Modification Recommended Service Note

EDU36311A Smart Bench Essentials DC Power Supply

Serial Numbers: CN64290002 - CN64470407

The Problem – The unit may become non-operational (no output) after being powered on for a certain period of time.

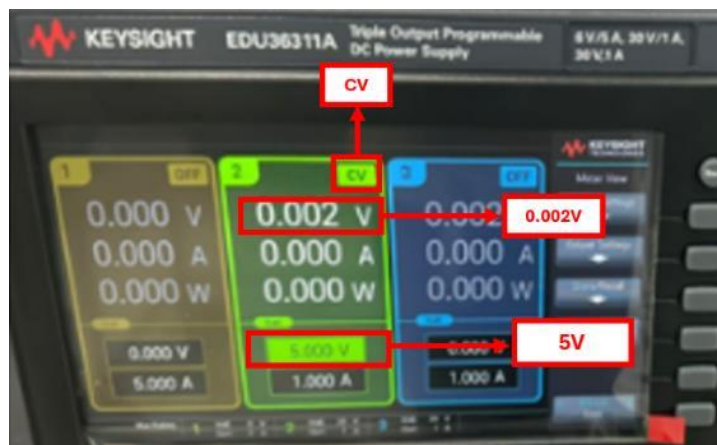
Unit within the serial number range may become non-operational (no output) after being powered on for a certain period of time.

***Please note that one or more channels may become non-operational.**

Kindly contact Keysight Technologies Customer Contact Center at www.keysight.com/find/contactus to arrange the return of the affected unit for unit exchange.

2) Unregulated

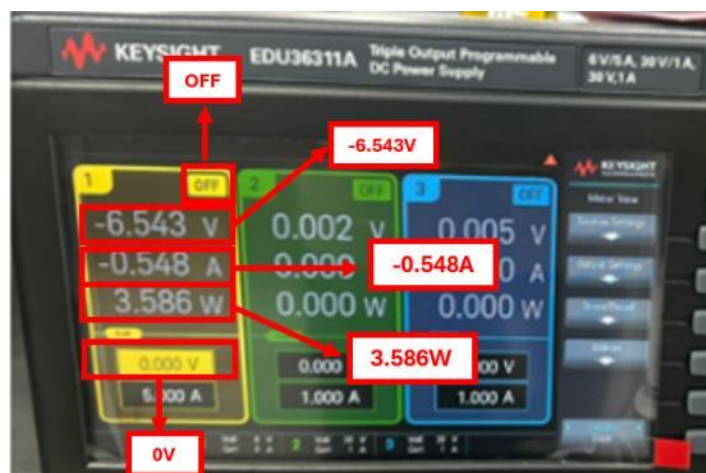
- The output remains off, but voltage, current, and power readings are still present.
- The readings can either be positive or negative.

3) Error code “-310, System error” AND “562, Analog board does not respond”

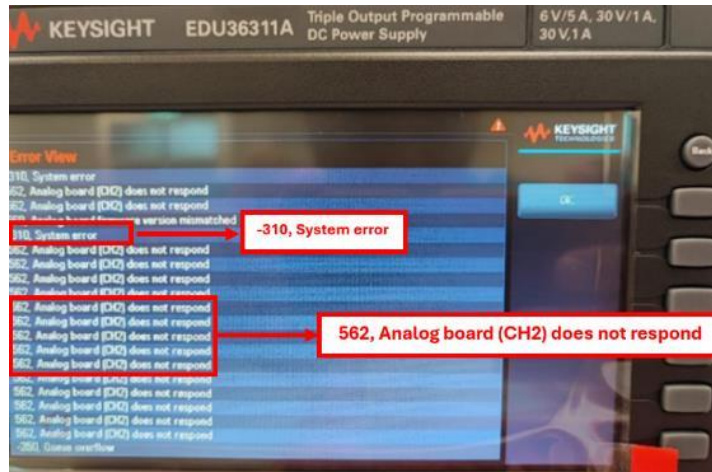
- The error will indicate the defective channel.
- In the example below, Channel 2 (CH2) is identified as defective.
